FAQ Title Non-Power Operations Clarifications

Plant: Callaway Energy Center

Date: May 20, 2016

Figure F-1 Review POSs, KSFs, Components, Cables, and Identify Pinch Points

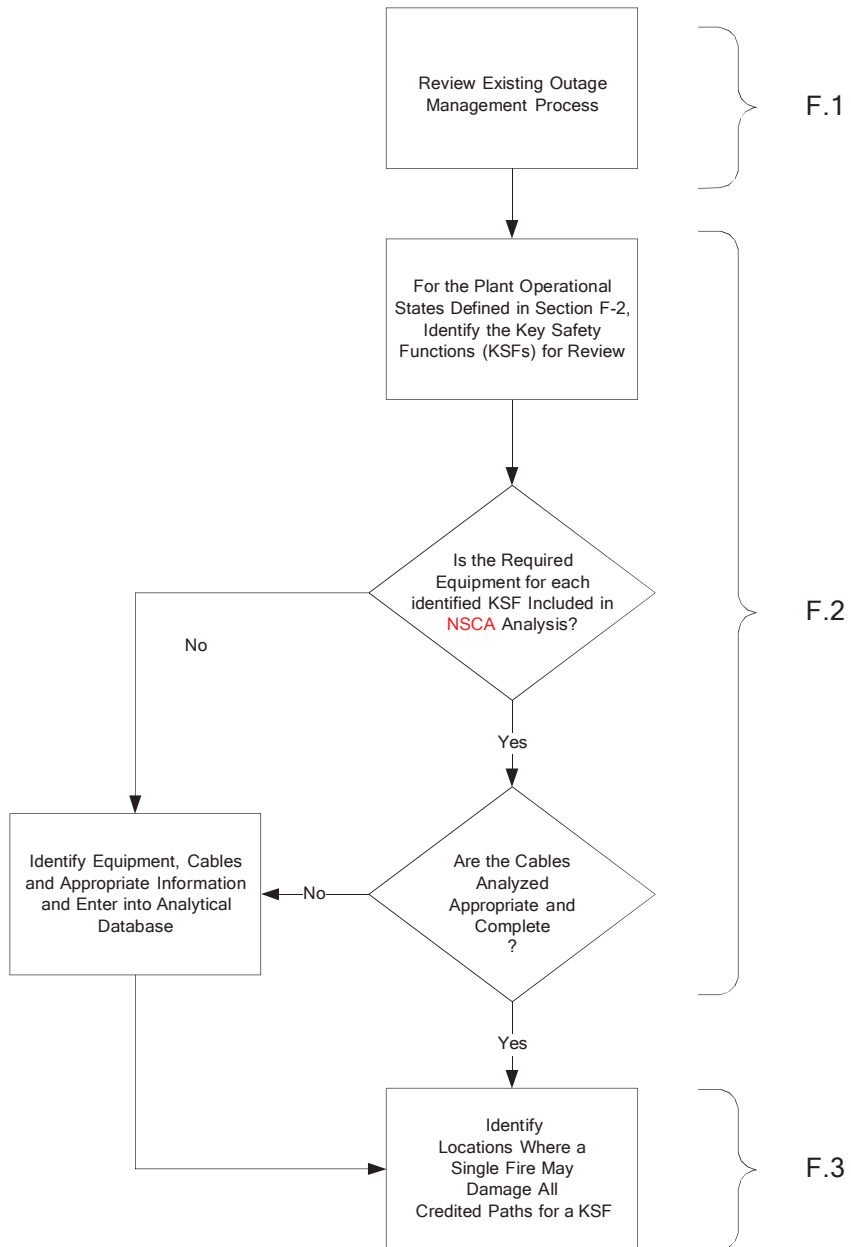
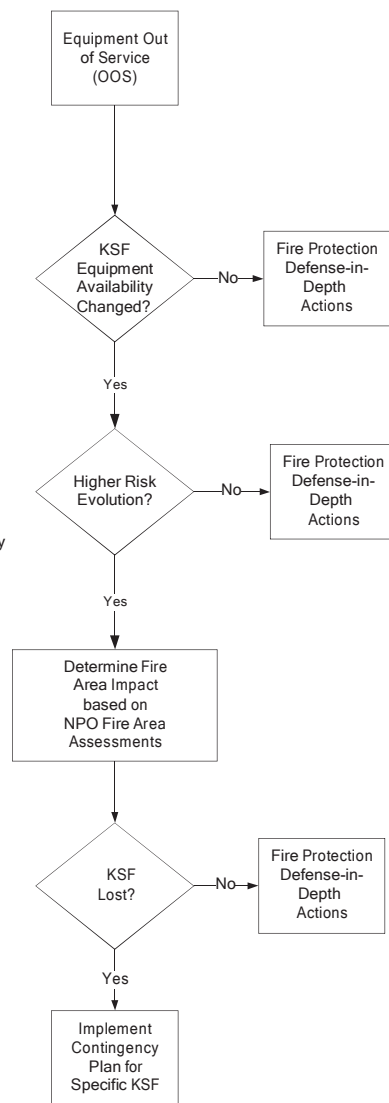
These steps are described in sections F.1 through F.4 below and the process is depicted on Figures F-1 and F-2. Implementation of the process should be documented in Table F-1.
